Addendum 10

Re: White Mountain Apache Tribe – Fort Apache Boys Dormitory Remodel
LSW Project No. 2020-175.000

Subject: Delta 2 (Addendum 10) MPE Revisions

DRAWN	IC
CHECKED	ELB
DATE	08.16.2023
SCALE	3/16" = 1'-0"
JOB NO.	2101
SHEET	E2.01

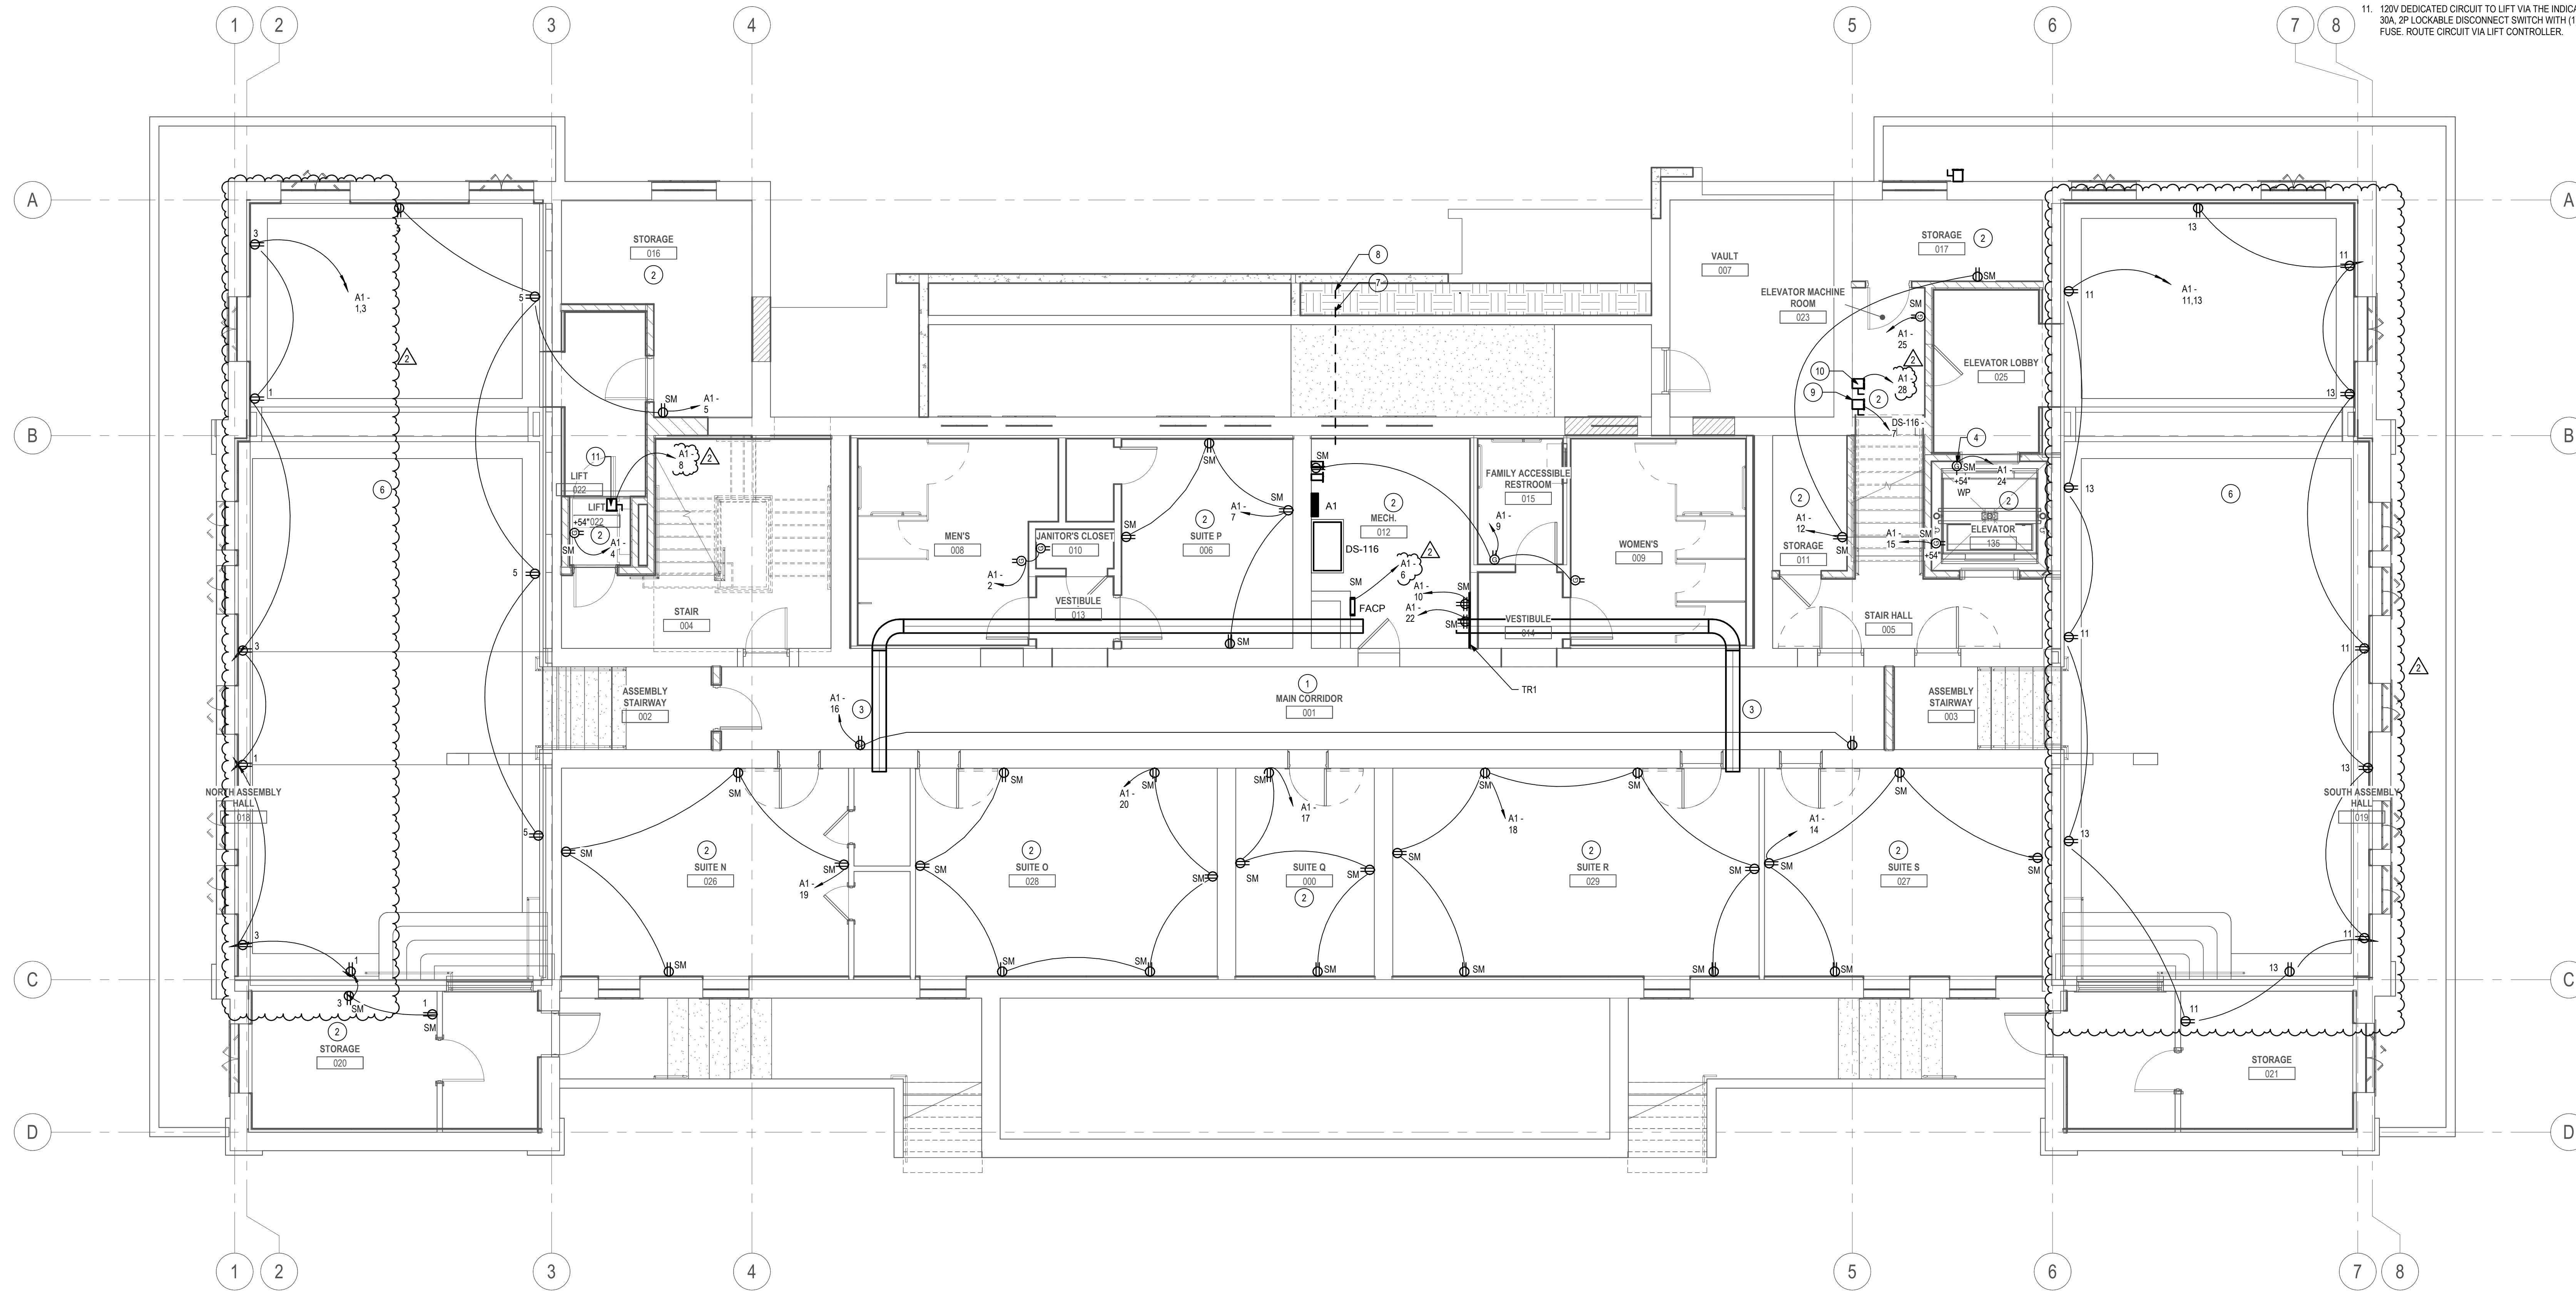
3. Updated plan views to show the receptacles and circuits in the Assembly spaces per bidder clarifications.
4. Updated circuits for Lift, FABP and Elevator cab lighting to better balance loads after pump changes noted above. There are no changes to circuit/breaker sizes.

DRAWN	IC
CHECKED	ELB
DATE	08.16.2023
SCALE	3/16" = 1'-0"
JOB NO.	2101
SHEET	E2.03

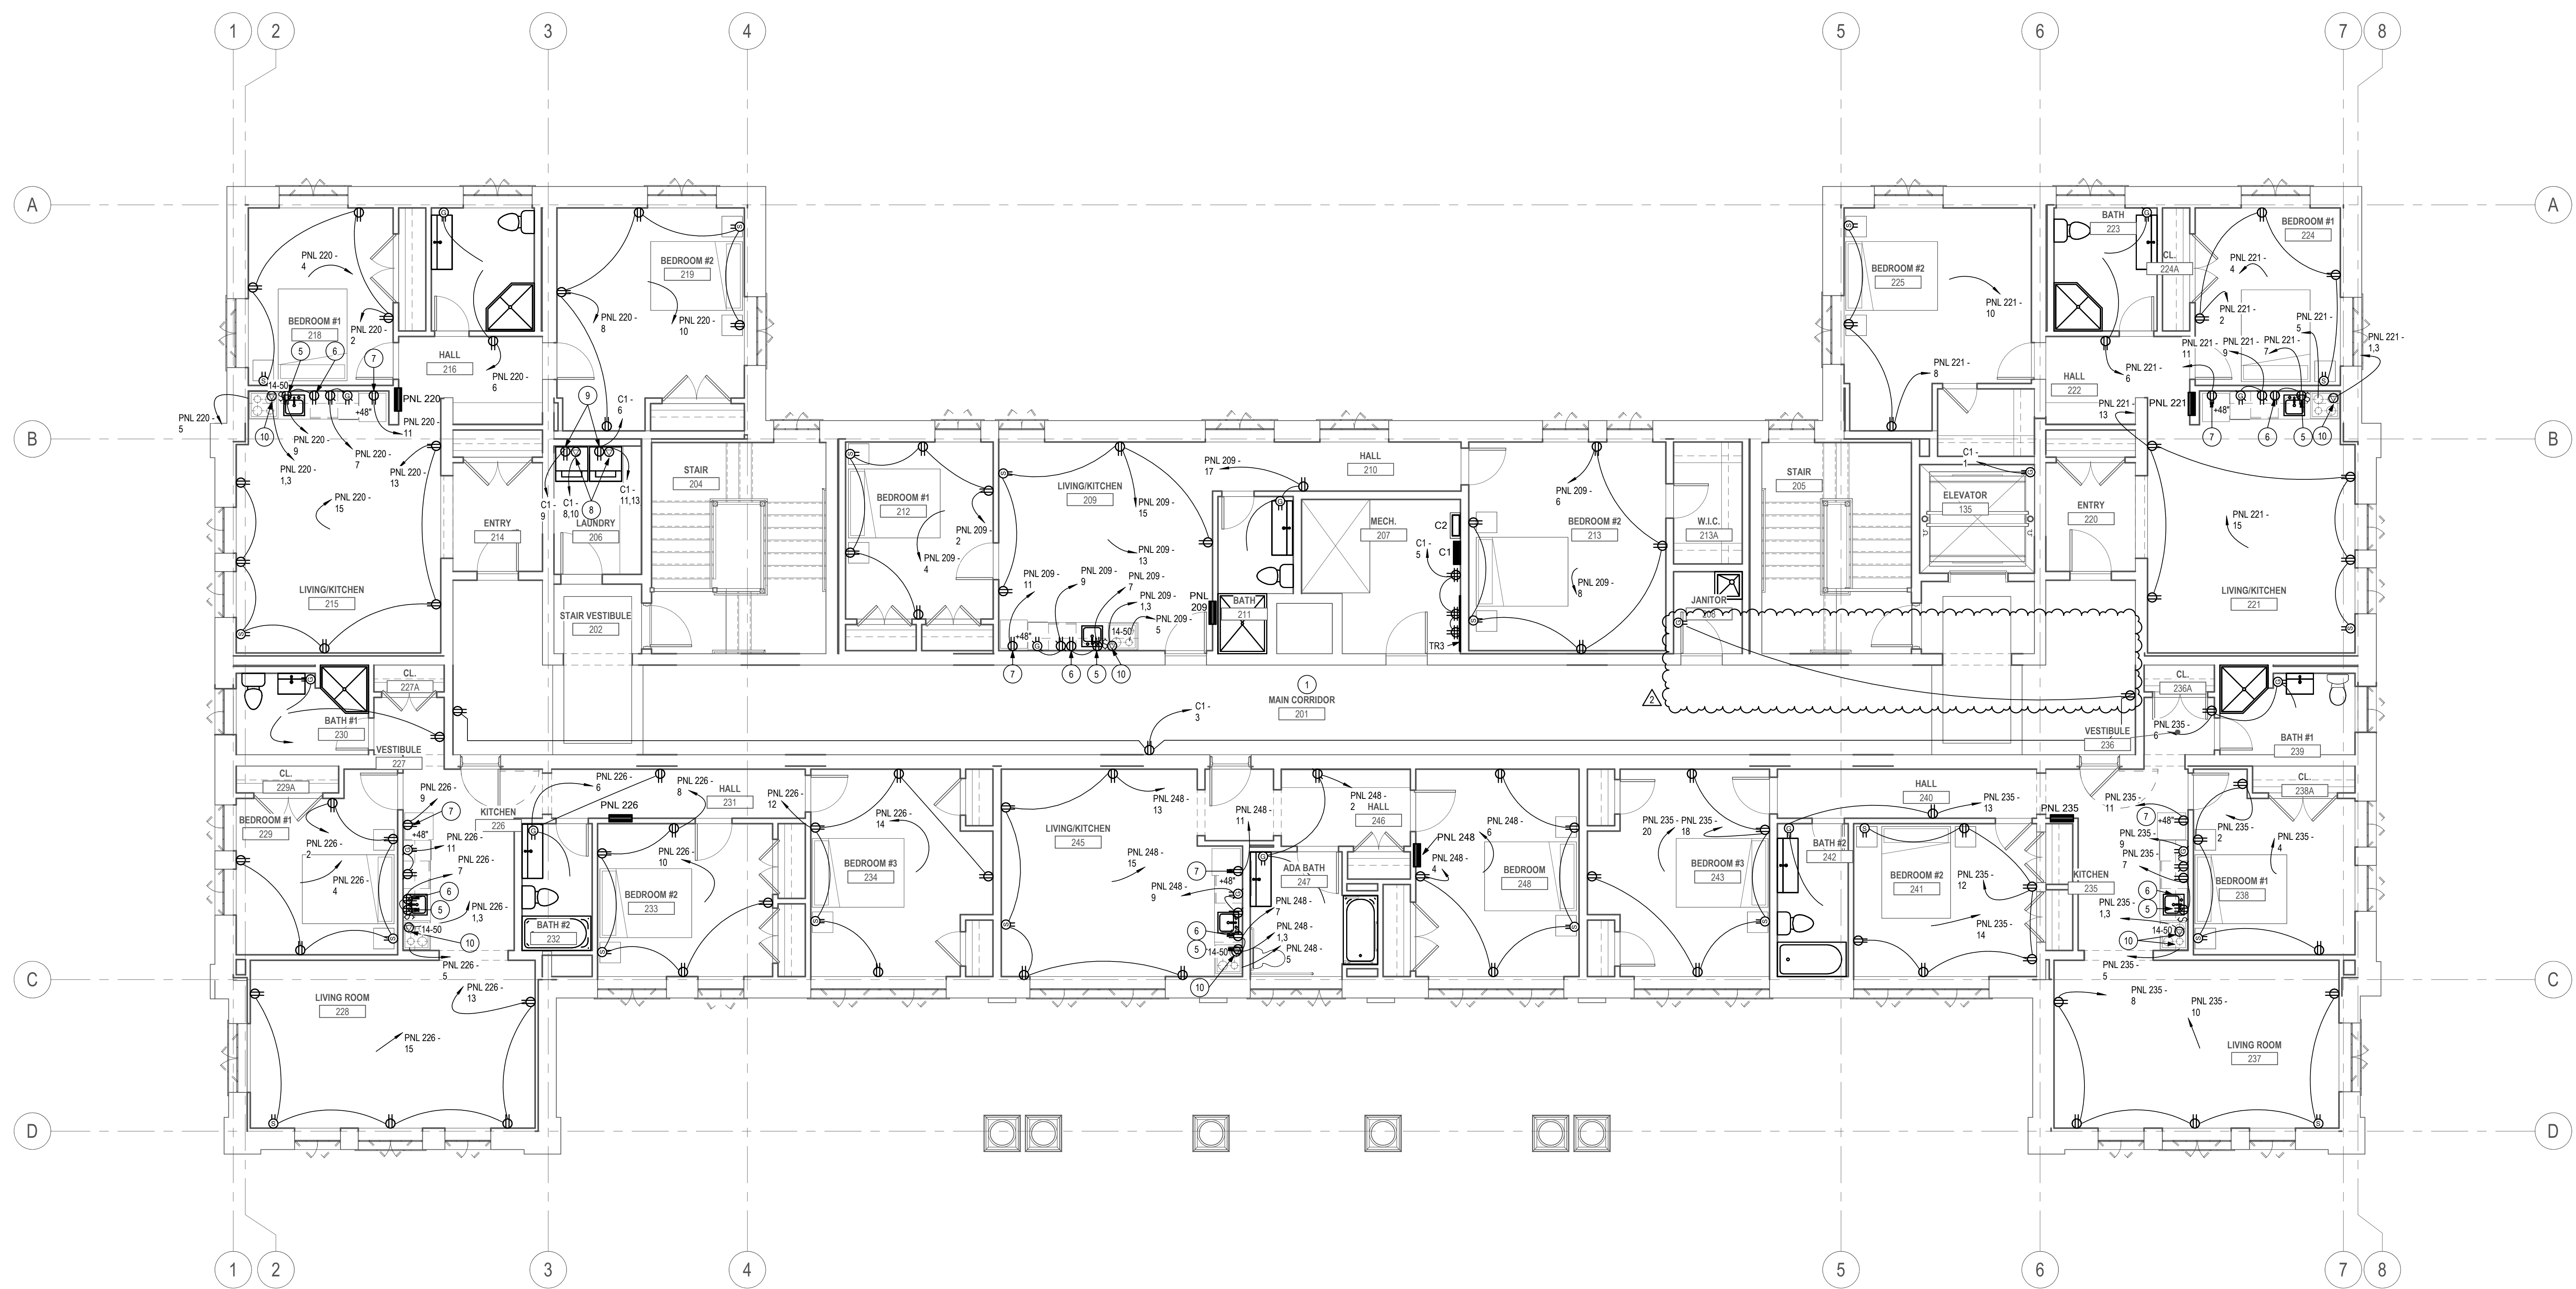
5. Updated circuits for janitor receptacle to better balance loads after pump changes noted above. There are no changes to circuit/breaker sizes.

DRAWN	IC
CHECKED	ELB
DATE	08.16.2023
SCALE	3/16" = 1'-0"
JOB NO.	2101
SHEET	E3.01

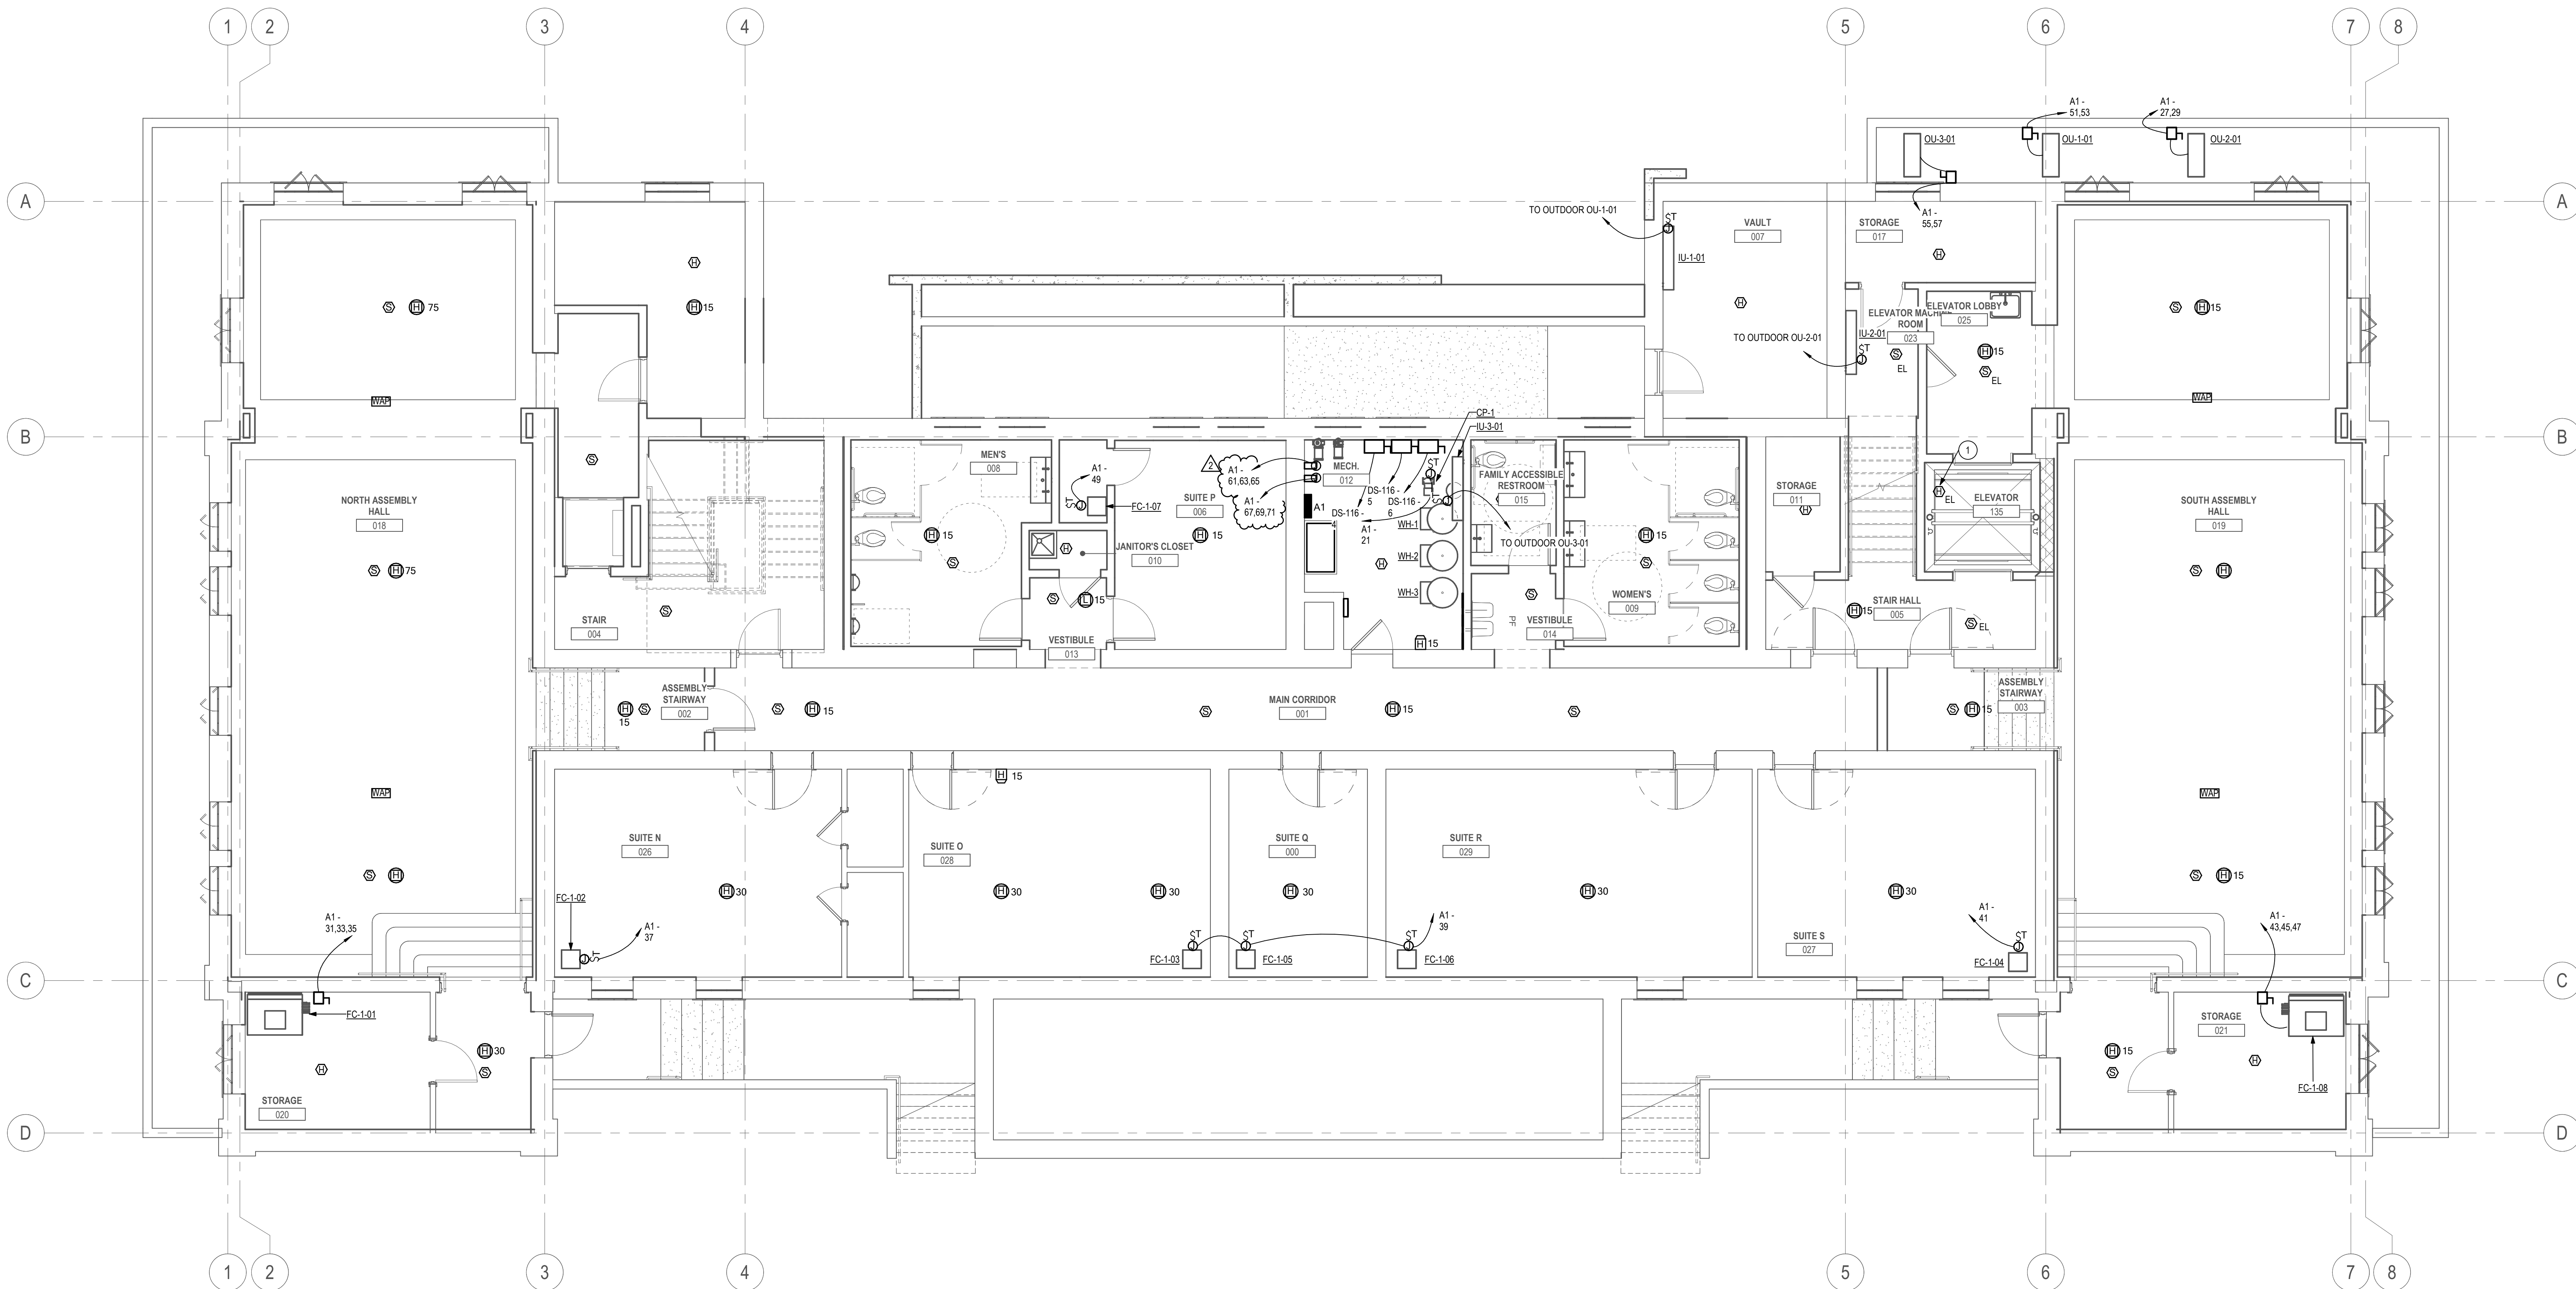
6. Updated circuits for pumps P-1-01 and 02 change to 3 phase motors per response to bidder question.
